Boulder Design Advisory Board Agenda

Pearl Place

BDAB Review Submittal 2 Preview Document

September 5, 2014

Summary of Key Changes - Building A

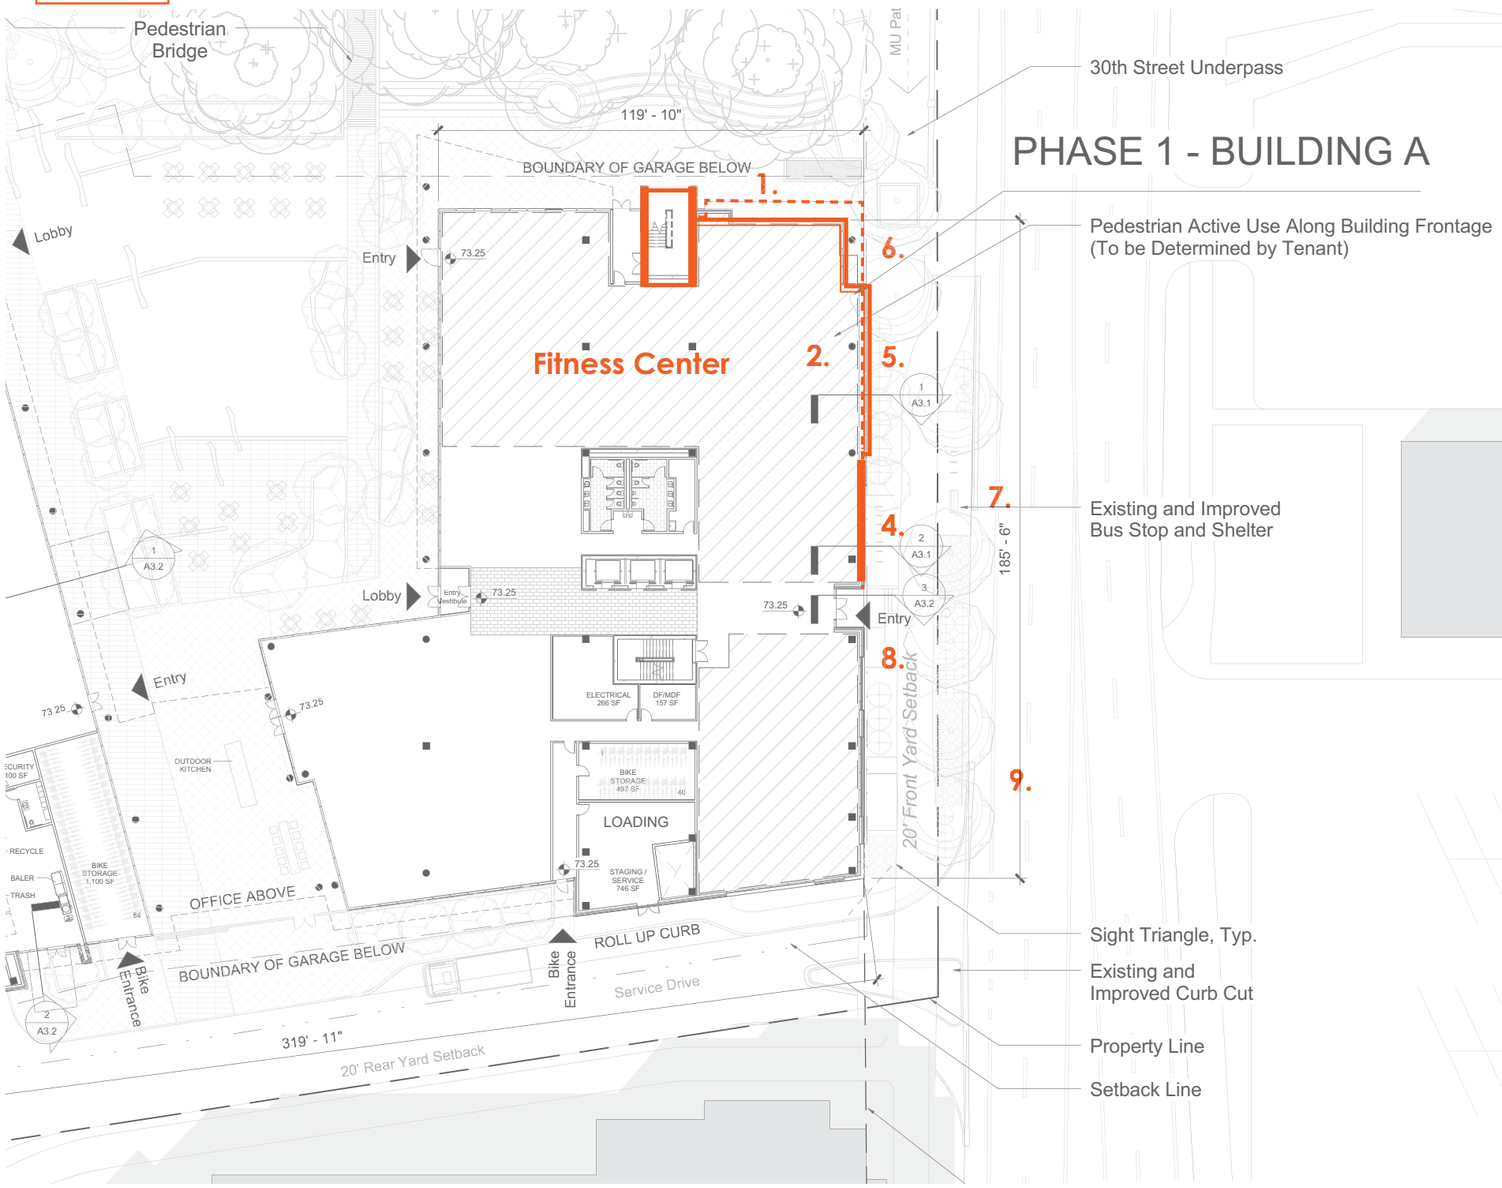
5.1.A BDAB COMMENT AND BVRC REFERENCE

5.1.A 1. Stair and north ground floor frontage pulled south to shorten length of street facade

5.2.E 2. Ground floor facade moved east to enclose columns

5.2.E 3. Design developed to provide a varying sequence of conditions at the base of the building to animate the pedestrian experience.

5.2.E 4. Short masonry wall at south end of volume 'grounds' the block, frames entry and provides background for signage and bike parking.

5.2.E 5. Projecting box window frames activity from both within and without and provides a vertical glass module at the street edge.

5.1.E 6. Recessed facade at the north allows the volume to float and defines an outdoor garden room within the trees.

3.8.A 7. Bus stop moved north to avoid conflict at 30th Street entrances.

5.2.E 8. Facades developed to provide a counter rhythm of vertical openings, fins and joints to balance horizontal.

5.2.E 9. Street trees at regular centres

Summary of Key Changes - Building C

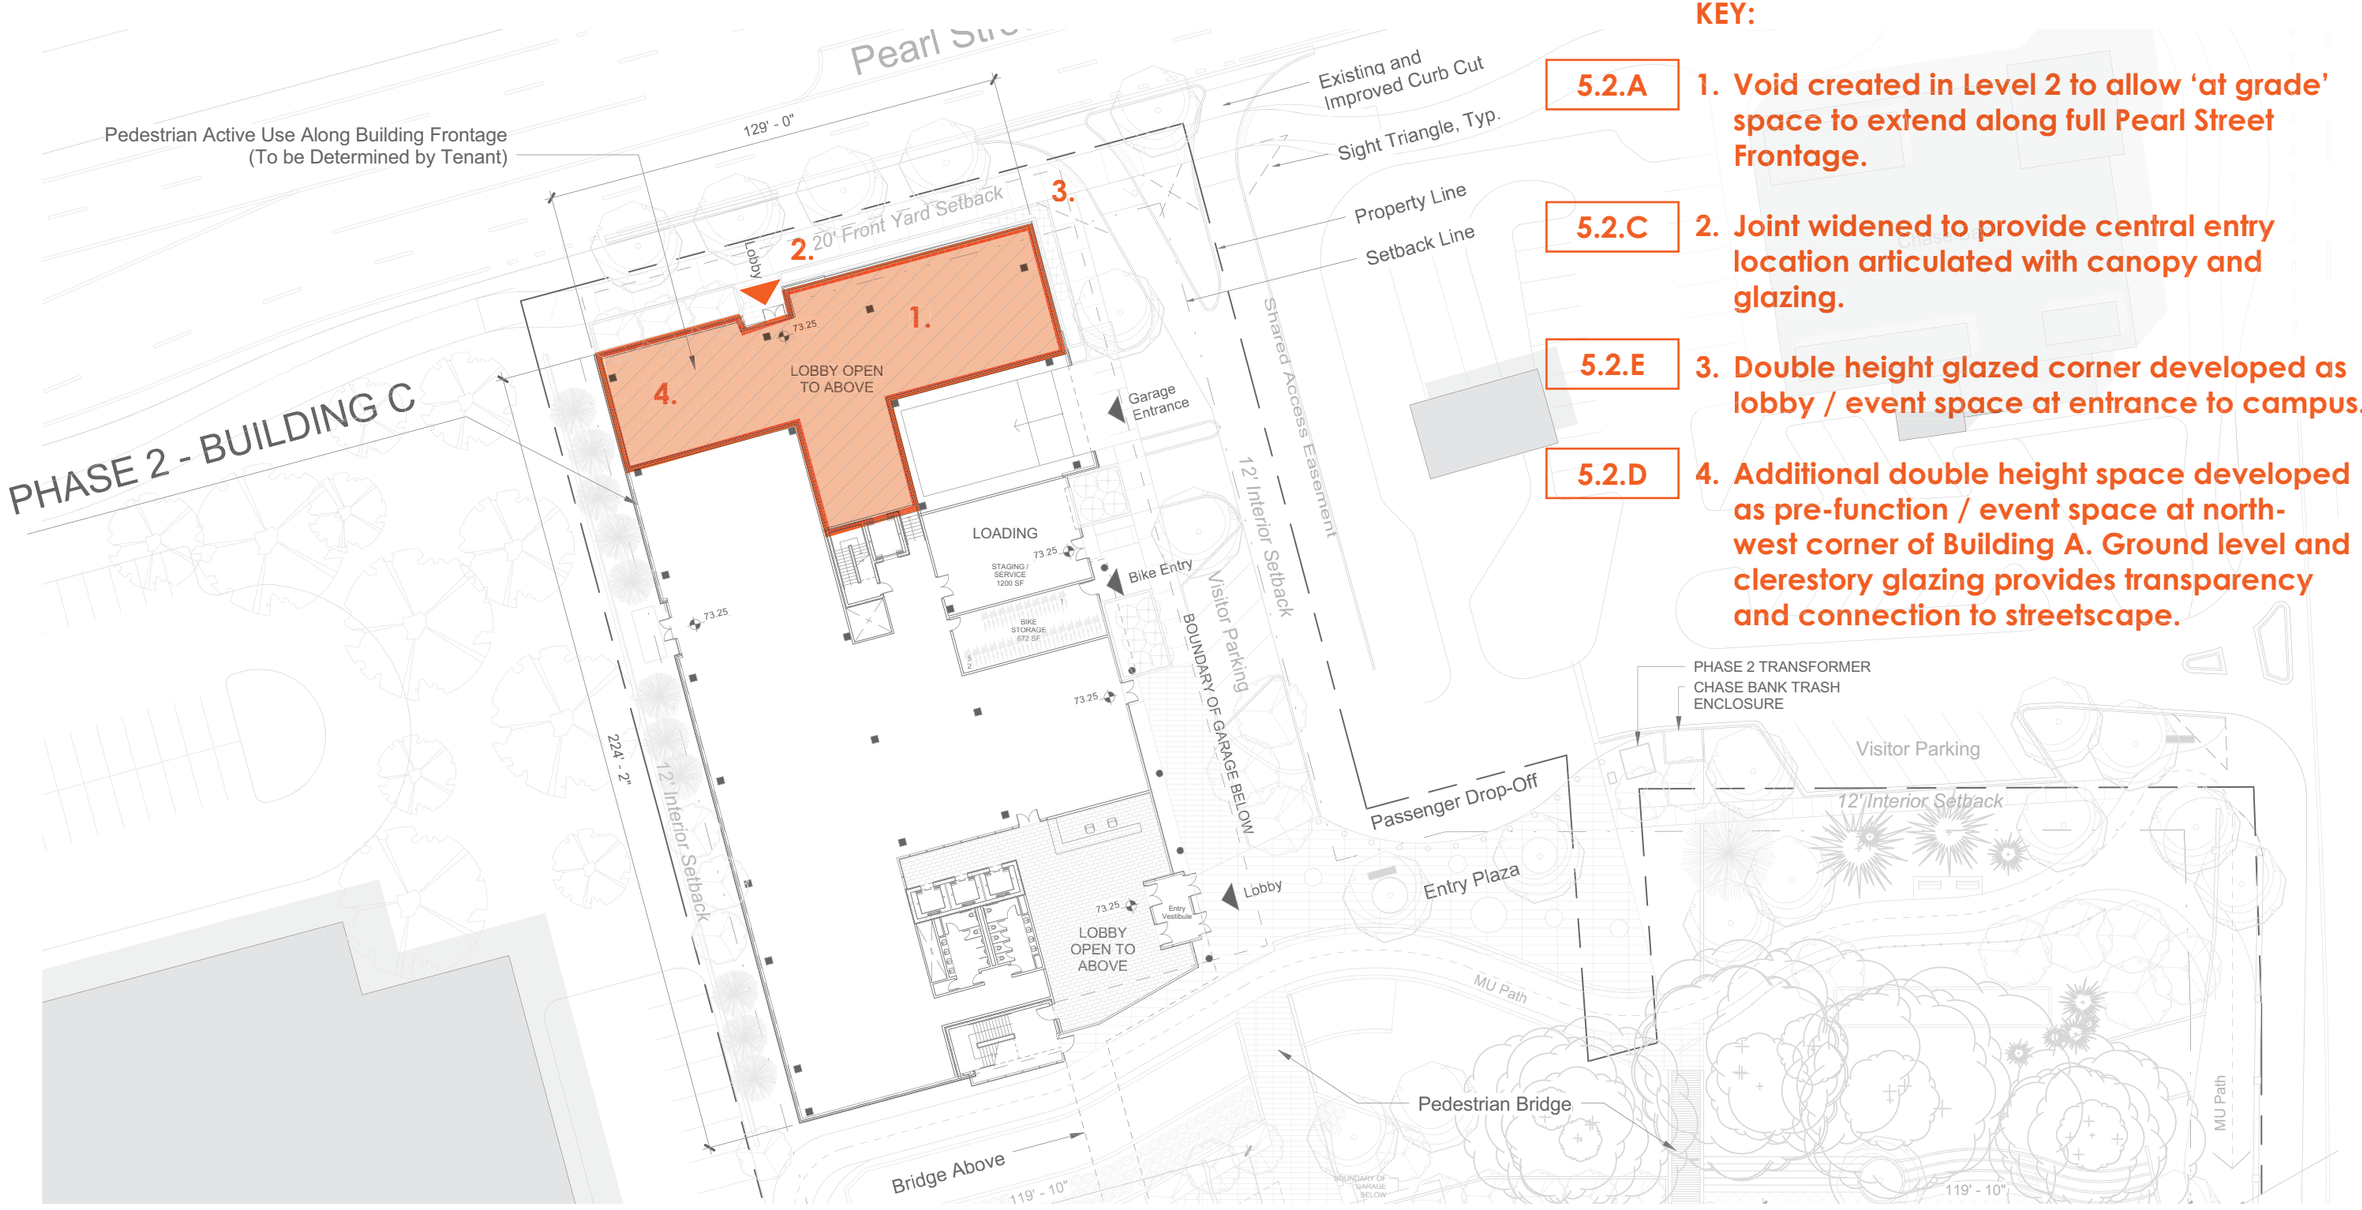
5.2.A 1. Void created in Level 2 to allow 'at grade' space to extend along full Pearl Street Frontage.

5.2.C 2. Joint widened to provide central entry location articulated with canopy and glazing.

5.2.E 3. Double height glazed corner developed as lobby / event space at entrance to campus.

5.2.D 4. Additional double height space developed as pre-function / event space at north-west corner of Building A. Ground level and clerestory glazing provides transparency and connection to streetscape.

Pearl St. Elevation

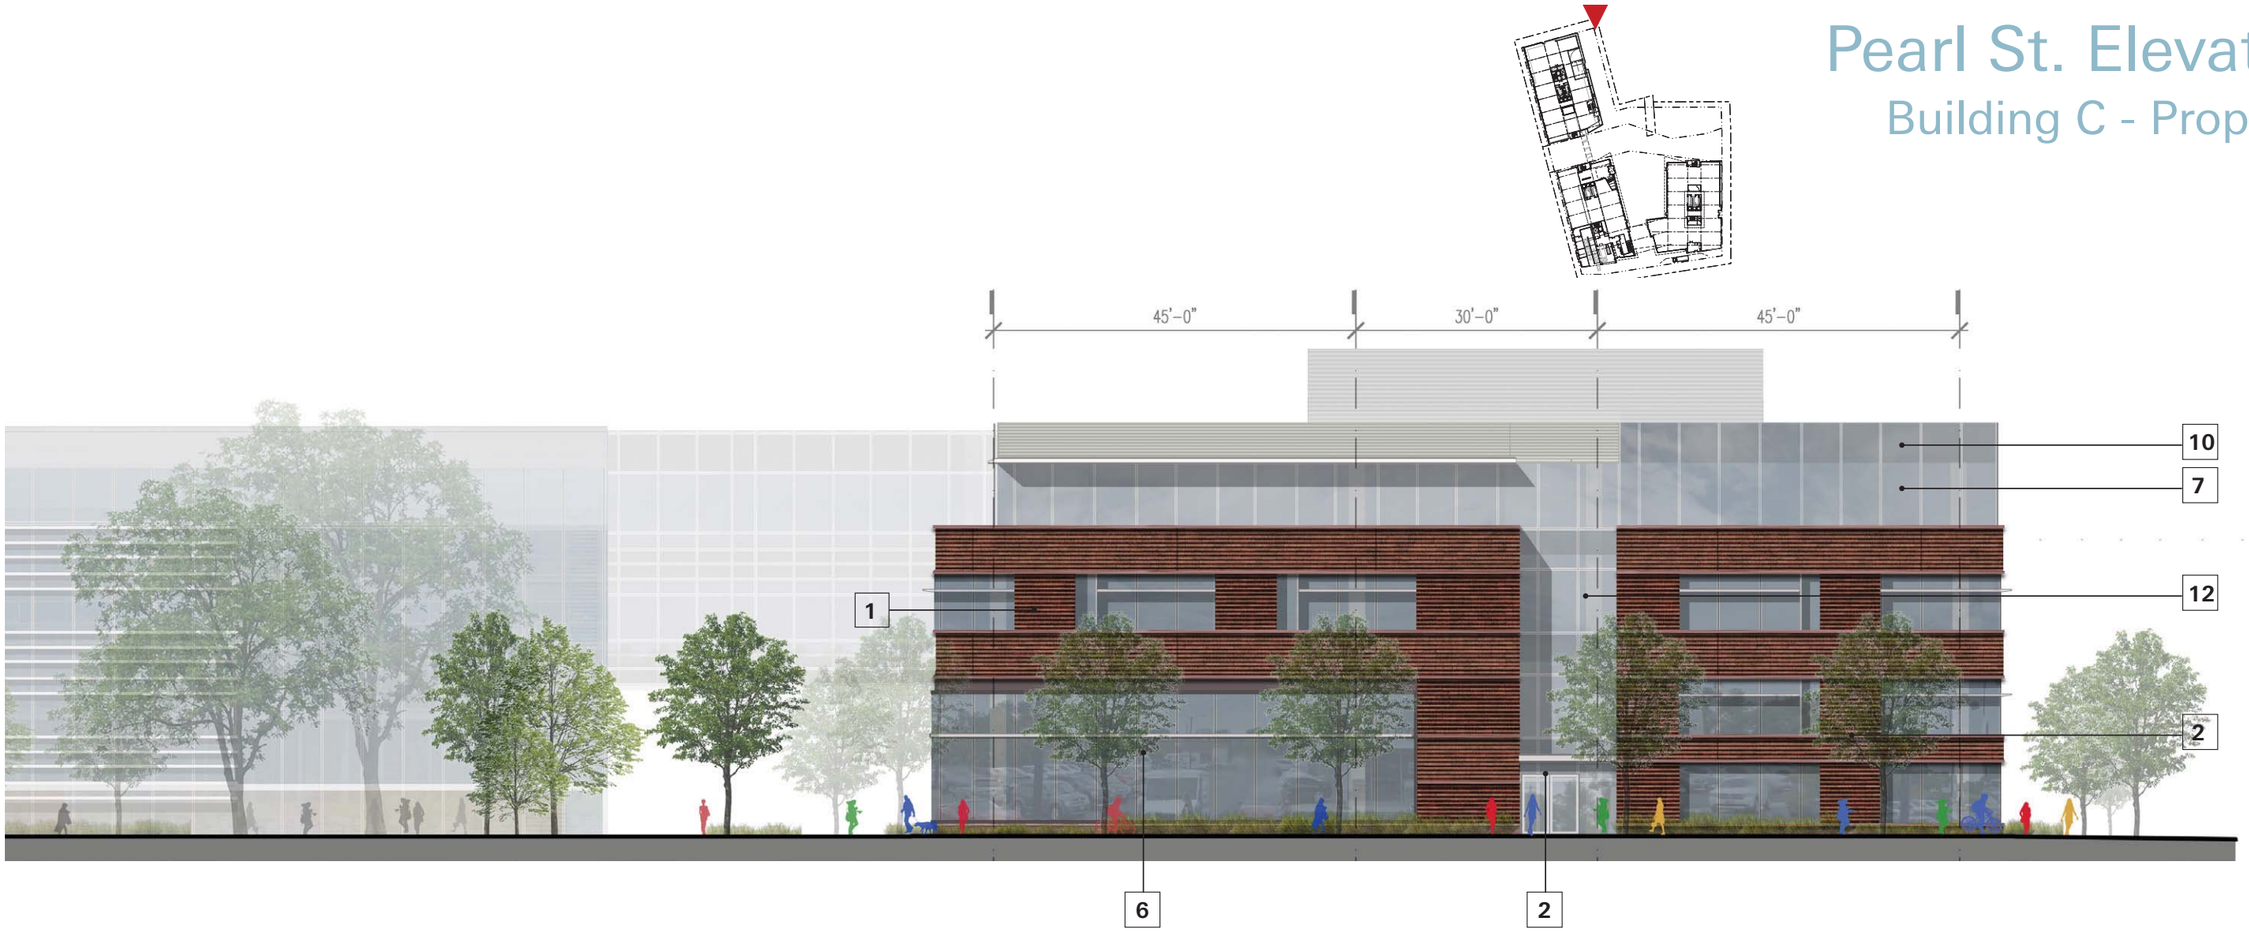
5.2.E

A two storey glazed volume at the entrance to the campus provides increased transparency and enlivens the streetscape by exposing interior activity.

5.2.C

The glazed joint between the primary volumes is widened and articulated with a canopy to provide a clear and welcoming entry.

5.2.D **5.2.A**

Double height space is extended across the full width of the north facade to provide street level glazed frontage in all locations. Masonry grounds the western volume and frames the double height space within.
